SAFETY RECALL NOTICE

McLaren Artura Voluntary Safety Recall – High Pressure Fuel Pipes Potential Replacement

Bulletin type:	Safety Recall Campaign
Reference number:	N/A
Campaign reference:	SRC 16 K 001
Attention:	All Retailer Staff
Affected vehicles:	McLaren Artura
Situation:	Replacement of the High Pressure Fuel Pipes
Procedure:	Action all affected vehicles. Please refer to the information outlined in this document to complete the required work
Date:	20 December 2022

Figure 1: Location of RH and LH GDI high pressure fuel pipes

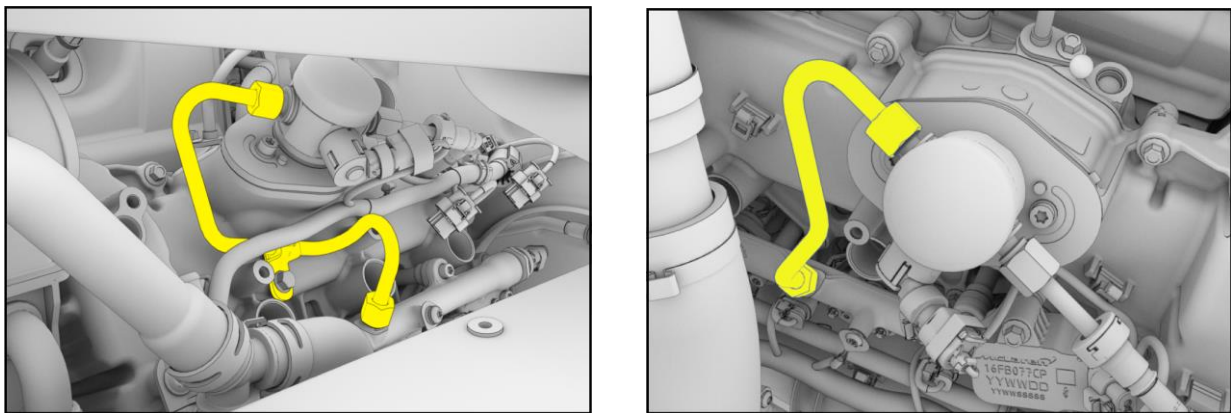
The covered vehicles may have been fitted with an incorrect high pressure fuel pipe which could cause a fuel leak and as a result an increased risk of thermal activity.

- a. Check the engine serial number found on the vehicle against the engine serial number list attached with this Campaign Bulletin
- b. If the engine serial number found in the vehicle is not in the engine serial number list attached with this Recall Campaign Bulletin, mark this Recall Campaign as completed for the vehicle by submitting the pre-approved Warranty claim attached to its VIN in the Retailer Portal. Please attach clear photos of the VIN number and engine serial number for each vehicle checked in the Warranty claim
- c. If the engine serial number found in the vehicle is is in the engine serial number list attached with this Recall Campaign Bulletin then proceed to replace **both (RH bank and LH bank)** GDI high pressure fuel pipes.

The below parts are required to action this rework and **replace both GDI high pressure fuel pipes**. All parts in the list below can be ordered in the usual way via Unidial 2.
